KIA-NWB-1: Sabina provided Memorandum “Back River -Water Management Infrastructure Design; Primary Pond - Slope Stability Analysis”, dated November 29, 2022

KIA-NWB-2: Sabina provided Technical Memorandum “Primary Pond Dam - Thermal Modeling Overview;”, dated November 29, 2022

KIA-NWB-3: Sabina provided additional climate information as part of the document “Back River: Updated Feasibility Study - Hydrology Update”, dated July 16, 2021.

Figure 1: Example layout for thermosyphon evaporator pipes to be installed the key trench

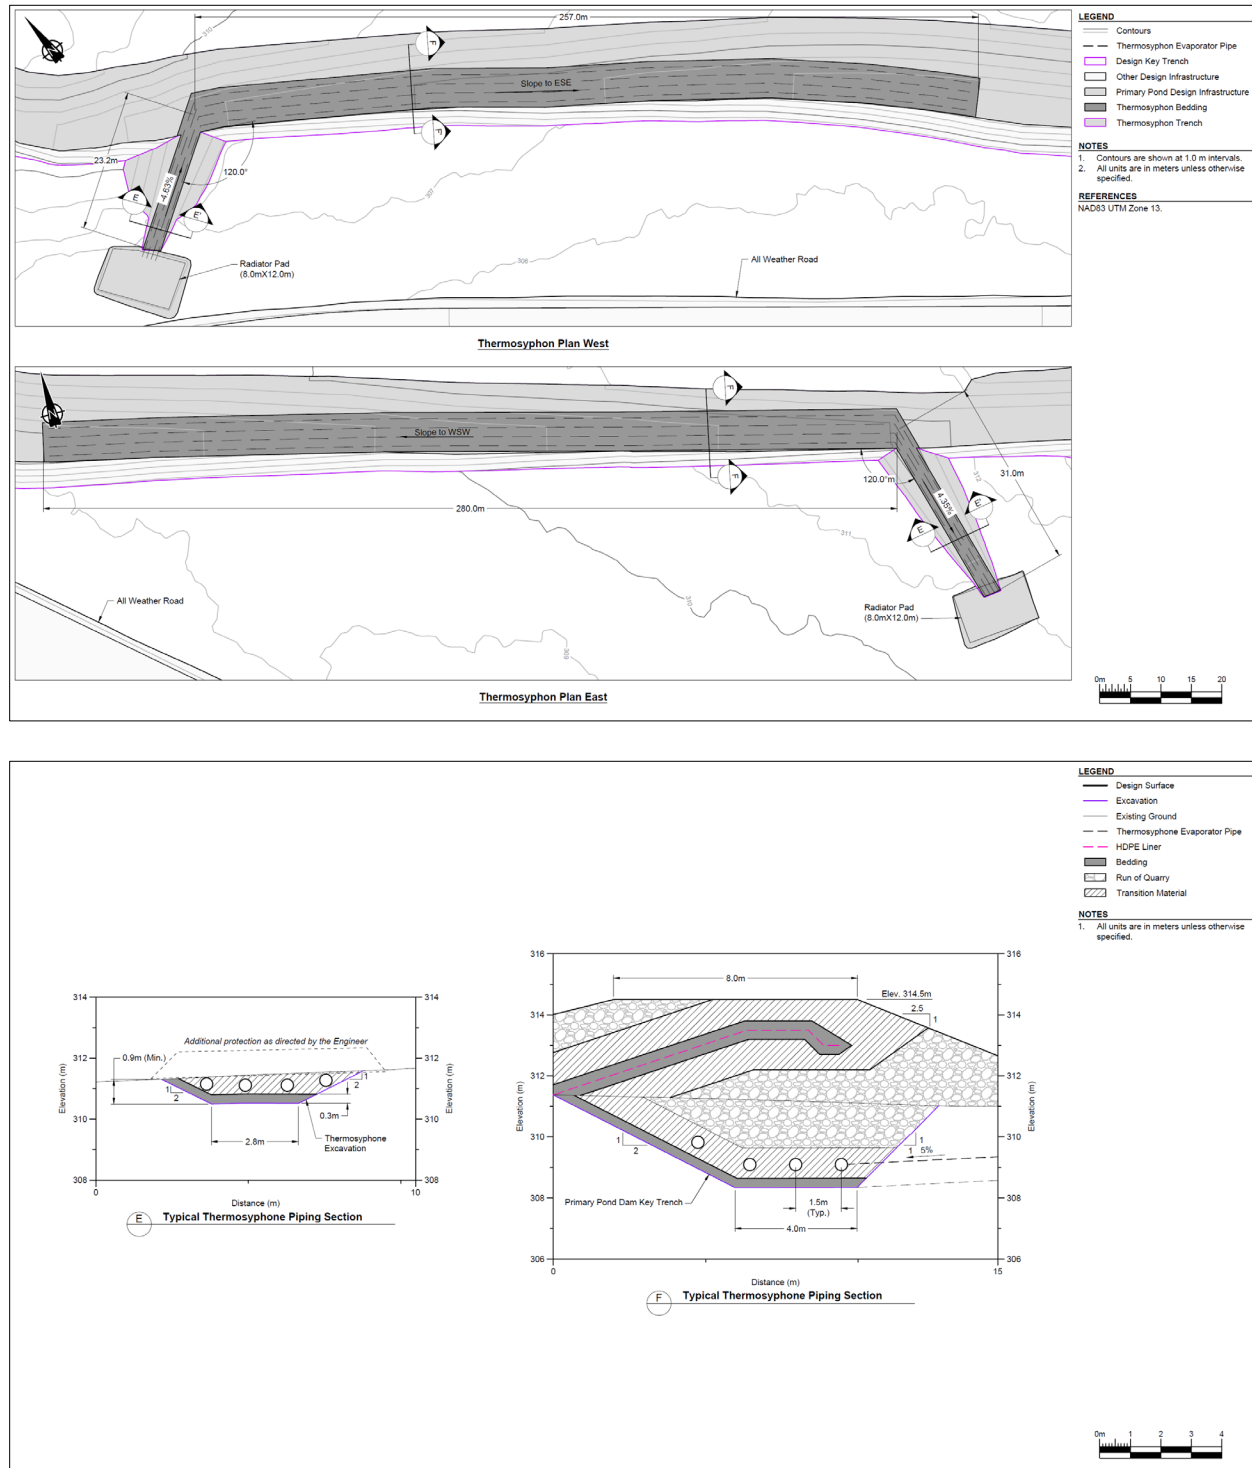
The thermal design report provides guidance on how to reduce uncertainty related to water seepage, which could include the installation of thermosyphons within the key trench. This option is repeated in Sabina’s response to KIA-NWB-2, but the original design does not show any thermosyphons nor that measures would be included that would late allow to install thermosyphon evaporator pipes in the future.

In regards to the uncertainty around the water seepage at locations where the liner is keyed into permafrost soils, Sabina has further consulted SRK Consulting (Canada) Inc. and revisited the potential risks. Sabina have decided to adopt a conservative and proactive approach and are actively working towards integration of a thermosyphon system at two locations where the dam key trench is constructed on permafrost soil. Sabina has engaged SRK who is now working with Arctic Foundations Canada to determine what can be installed within the 2023 construction season.

At this time the first approach that is being advanced is to install the thermosyphon evaporator pipes within the Primary Pond key trench. Only the evaporator pipes would be installed during the winter construction season. These pipes would be welded, and leak tested. At a later date (post May 2023), the radiators could then be installed onto the end of these evaporator pipes and the system charged with the two-phase working fluid. These evaporator pipes would be installed within the existing key trench design. The only modification to the presented key trench design would be the addition of finer crush (bedding) fill material around the thermosyphon evaporator pipes. Figure 1 below show an example layout of how the horizontal thermosyphons could be installed within the current key trench design.
